USB Cabin Power Interface for NAV III Option Airplanes ICA Supplement

MODEL NO: 182

**SUPPLEMENT NO: ICA-182-24-00001
SUPPLEMENT DATE: 12/23/2020**

ICA-182-24-00001	Rev: -	Date: Dec 23, 2020
ICA Summary	Pages 1-6	
Manuals Affected	Description	Title
Maintenance Manual	24-60-02 pages 101-106	12-V Cabin Power System
<ul style="list-style-type: none"> Added description, removal/installation, adjustment/test, and troubleshooting procedures for the new USB cabin power interface for NAV III Option Airplanes. 		
Appendix A: Illustrated Parts Catalog	Refer to Appendix A	See attached Parts Table.
Appendix B: Wiring Diagram Manual	24-50-01 Figure 05 pages 1-3	See attached Wiring Diagram.

DETAIL A
 AIRPLANES 18283121 AND ON

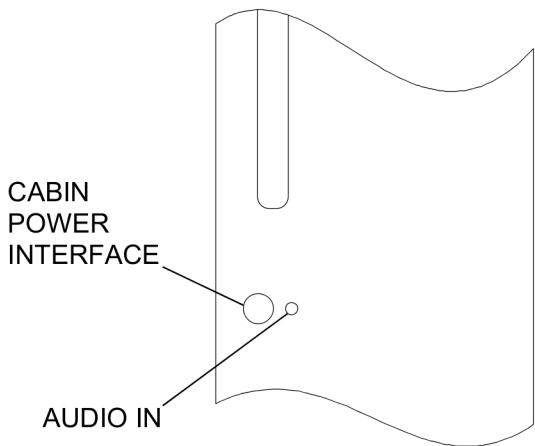
- D. Airplanes 18283121 and On with the NAV III option have a USB cabin power interface installed in the pedestal in place of the 12-Volt cabin power interface. The USB interface is a self-contained, DC-DC power converter with USB type A and type C outlets that are used to supply USB compatible electronic devices with power. The USB power interface obtains 28 VDC of current through the CABIN LTS/PWR (HI056) circuit breaker and does not connect directly to the power converter.

4. USB Cabin Power Interface Removal/Installation (Airplanes 18283121 and On with NAV III Option)

- A. Remove the USB Cabin Power Interface (Refer to Figure 101).
 - (1) Get access to the USB Cabin Power Interface wire bundle. Remove the pedestal cover assembly. Refer to Chapter 25, Interior Upholstery - Maintenance Practices.

- (2) Disconnect electrical connector JC024 from the ship-side connector PC024. Refer to 24-50-01, Figure 05 in the Model 182 (Series 1997 and On) Wiring Diagram Manual.

- (3) Remove the screws that secure the USB Cabin Power Interface to the pedestal cover assembly.
 - (4) Remove the USB Cabin Power Interface from the airplane.

- B. Install the USB Cabin Power Interface (Refer to Figure 101).
- (1) Put the USB Cabin Power Interface in its place on the pedestal cover assembly.
 - (2) Install the screws that secure the USB Cabin Power Interface to the pedestal cover assembly.

- (3) Connect the electrical connector JC024 to the ship-side connector PC024. Refer to 24-50-01, Figure 05 in the Model 182 (Series 1997 and On) Wiring Diagram Manual.

CABIN EQUIPMENT POWER INTERFACE W/NAV III OPTION
 Figure 05. (Sheet 1)

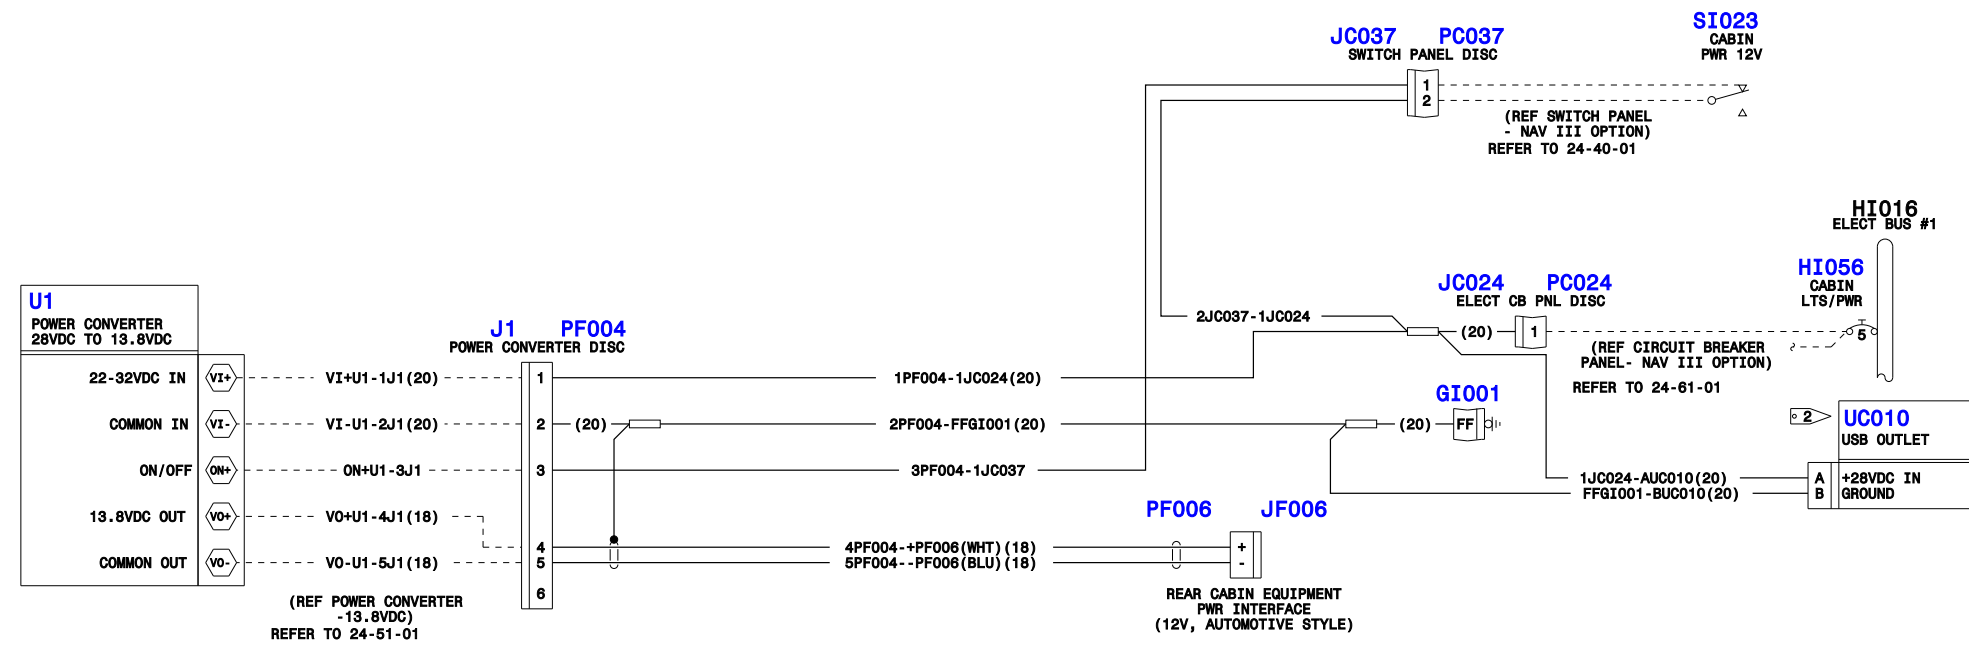
- 1. Model 182 (Series 1997 and On) Maintenance Manual**
 - A. Chapter 24 - Electrical Power
 - (1) Refer to Chapter 24-30-02 - 12-Volt Cabin Power System - Troubleshooting
- 2. Model 182 (Series 1997 and On) Wiring Diagram Manual**
 - A. Chapter 24 - Electrical Power
 - (1) Refer to Appendix B, 24-50-01, Figure 05 - Power Interface w/NAV III Option, 18283121 and On,
